CODE COMPLIANCE CERTIFICATE

Consent No: 130241

The Building		
Street address of building:	48 Eucalyptus Way, Paraparaumu Vacant Land	Building name:
Current, Lawfully established, use:		Location of building within site/block number:
Level/unit number:		Intended life of the building if 50 years or less:
Legal description of land where building is located:	LOT 2 DP 348721	Year first constructed:
The Owner		
Name of owner:	Roberts Peter Aled	Street address /registered office:
Contact person:		Phone numbers:
Mailing address:	C/-Shaun Taylor Mass Construction 169 Rimu Rd Paraparaumu 5032	Landline:
Email address:		Mobile: 027 3290711
Website:		Daytime:
		After hours:
		Facsimile number:
First point of contact for communications with the Kāpiti Coast District Council:		
Full Name: Mass Construction NZ Ltd Mailing Address: PO Box 1703, Paraparaumu Phones: 021 820671; 04 2989289 Email: brett.rollander@platinumhomes.co.nz		
Building Work		
Building Consent No:	130241	Issued by: Kāpiti Coast District Council

Project Description:	New Dwelling

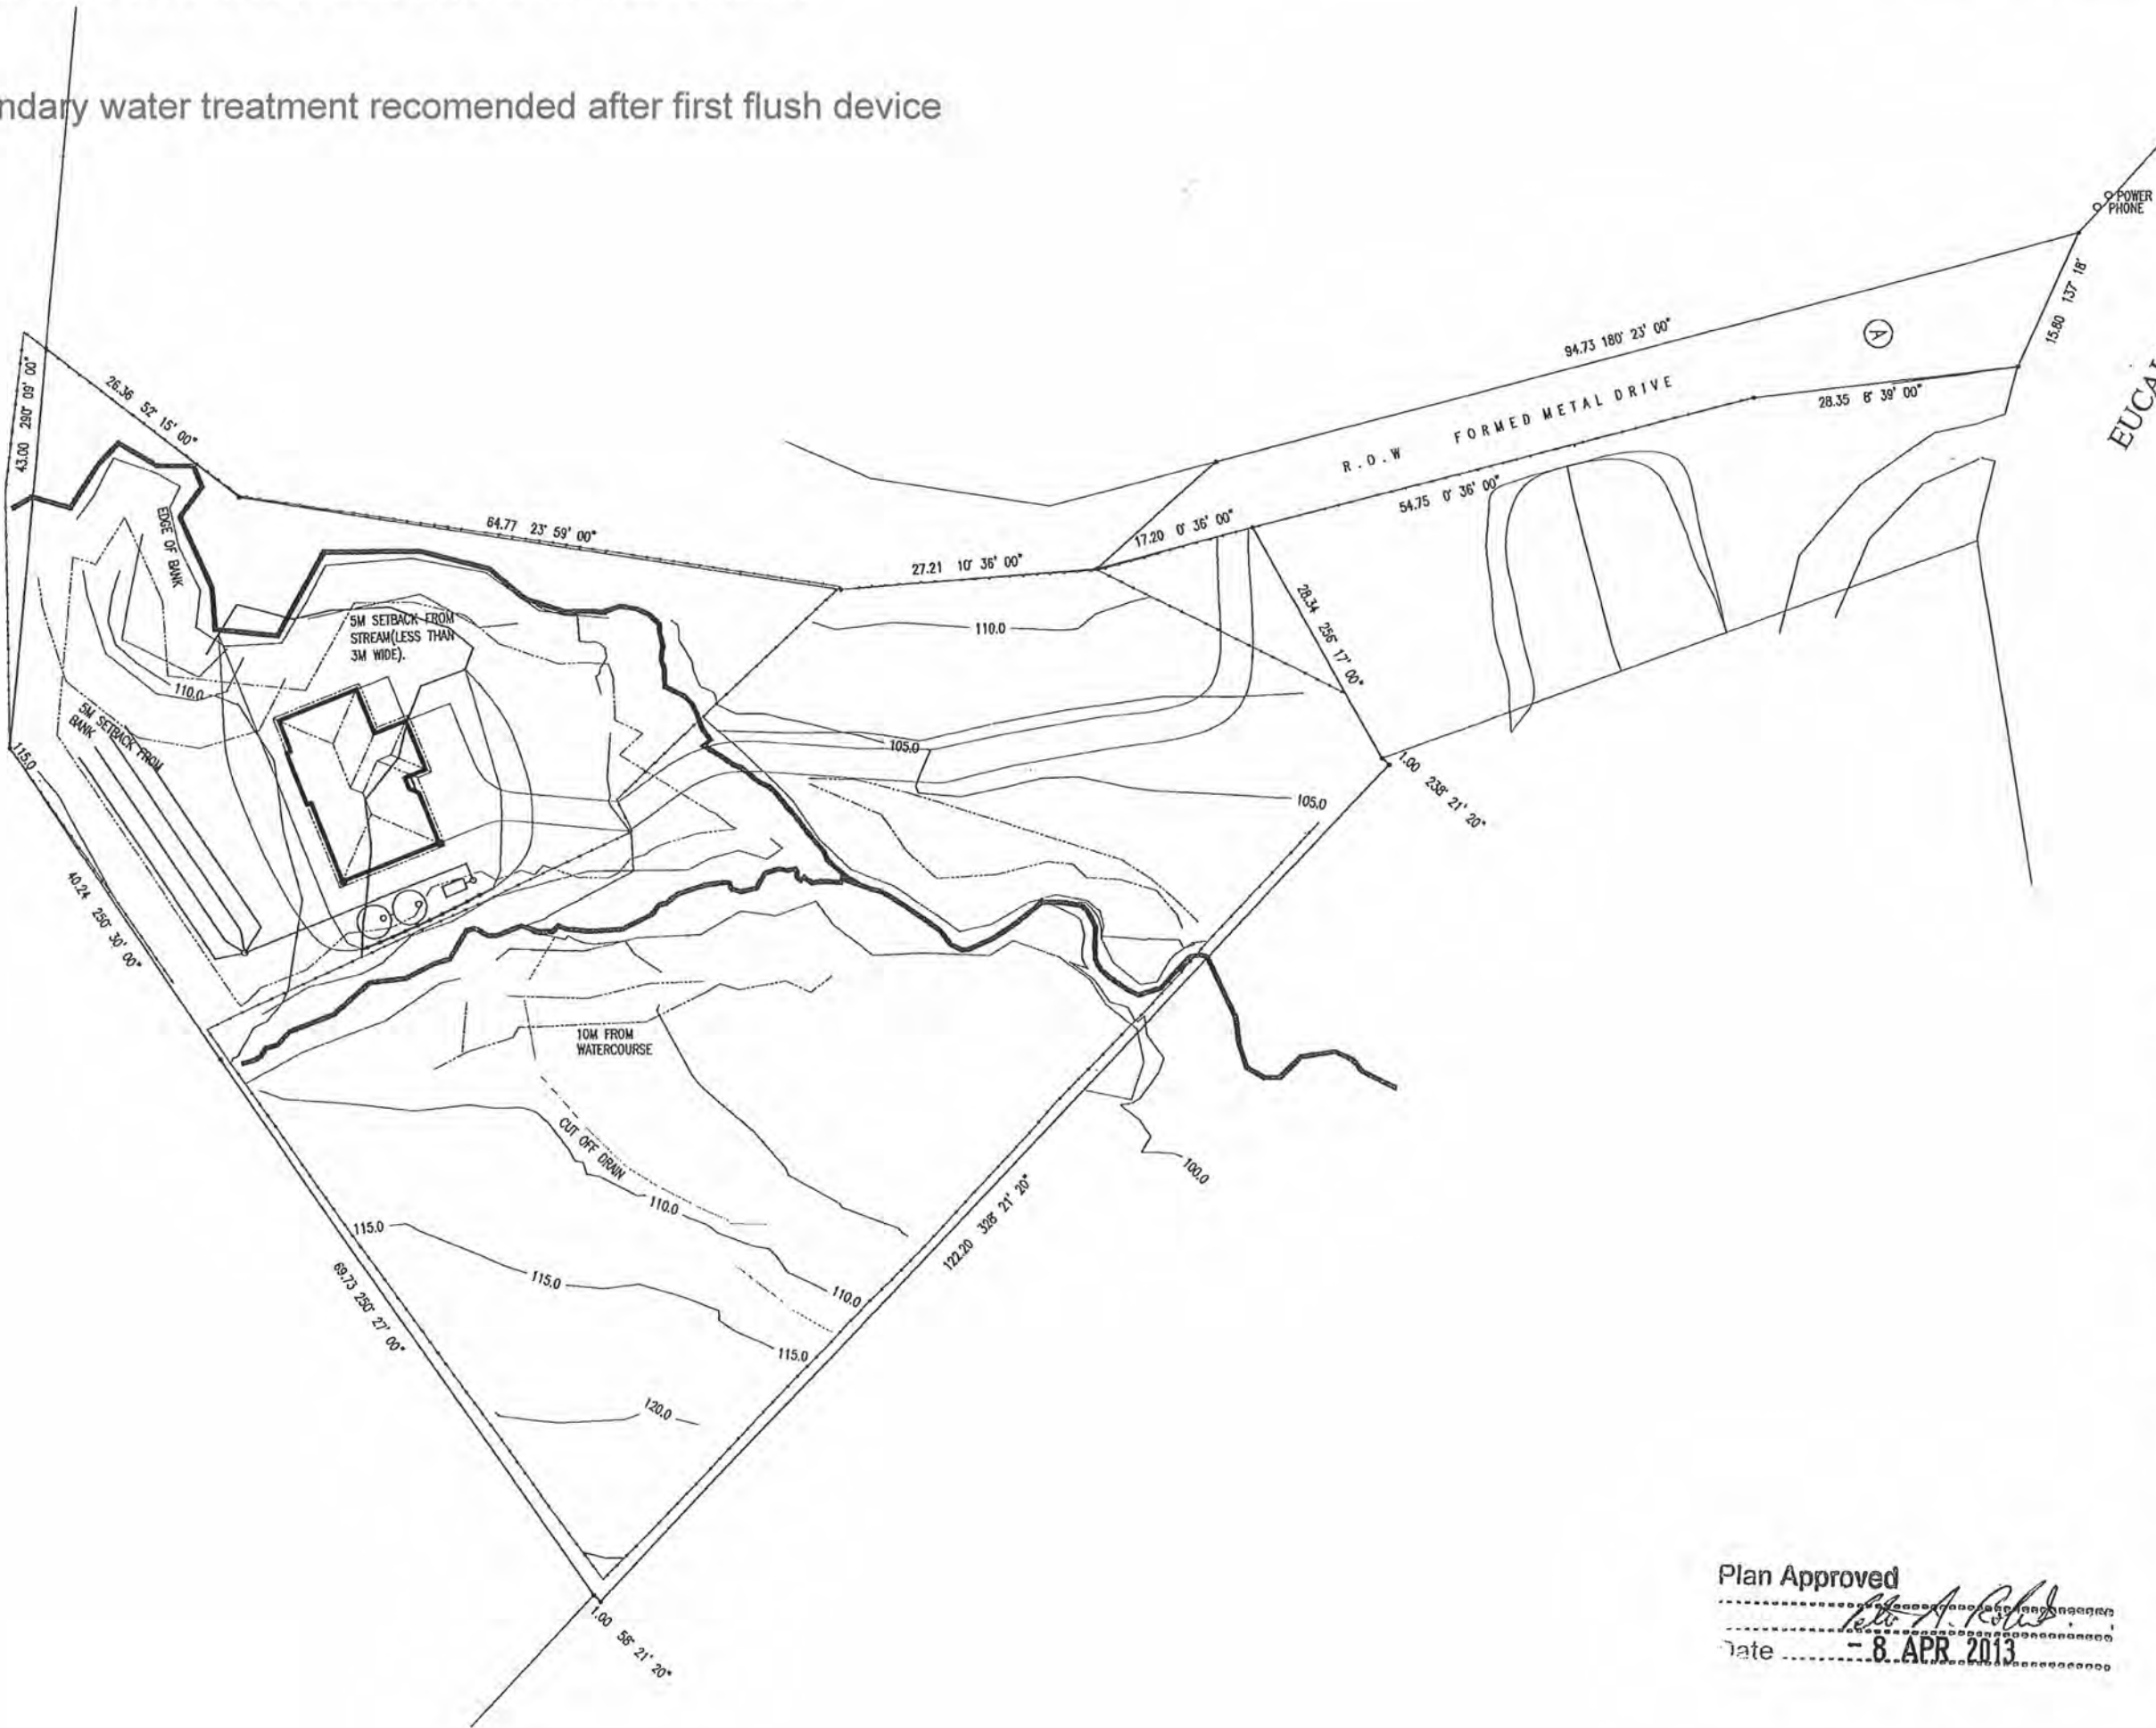
Check the potability of the water supply on a regular basis.

WATER STORAGE TANK NEED TO BE CLEANED OUT ON A REGULAR BASIS

Some secondary water treatment recommended after first flush device

Beam Mark-up
WJL #: 33104

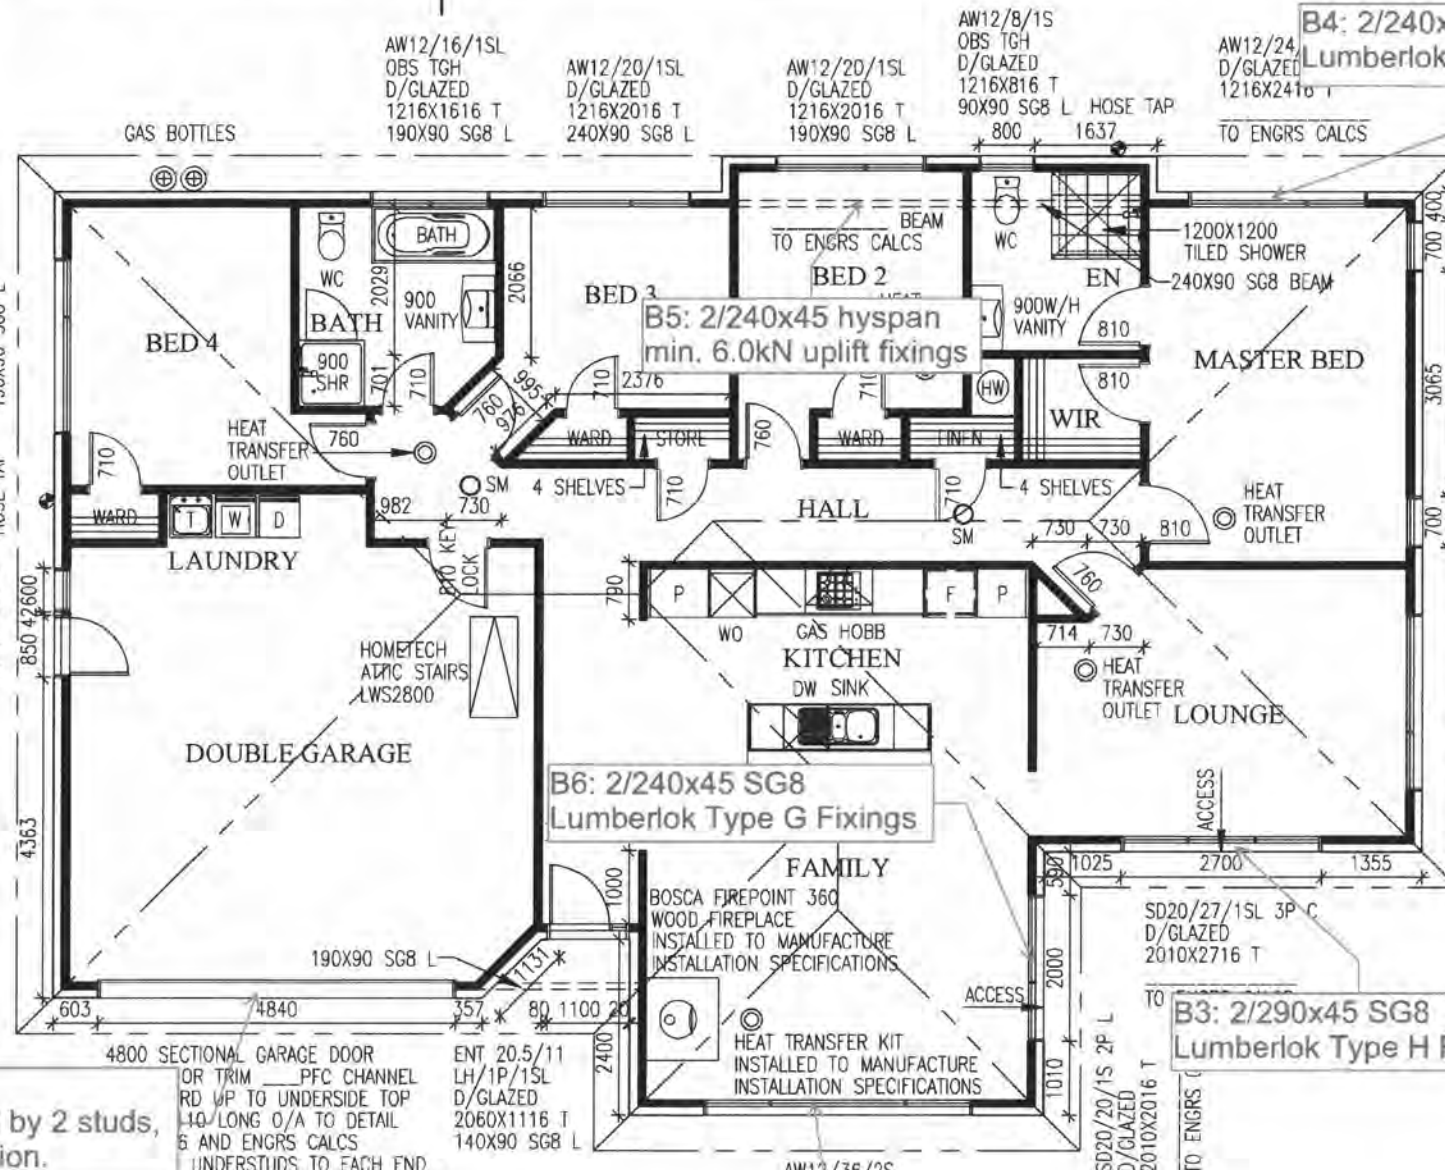
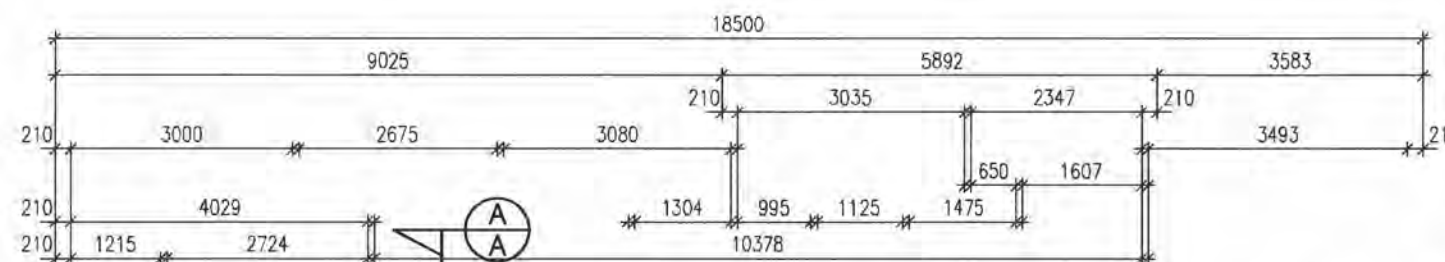
B1: 250PFC
on 2 studs & trimmed by 2 studs,
12.0kN base connection.
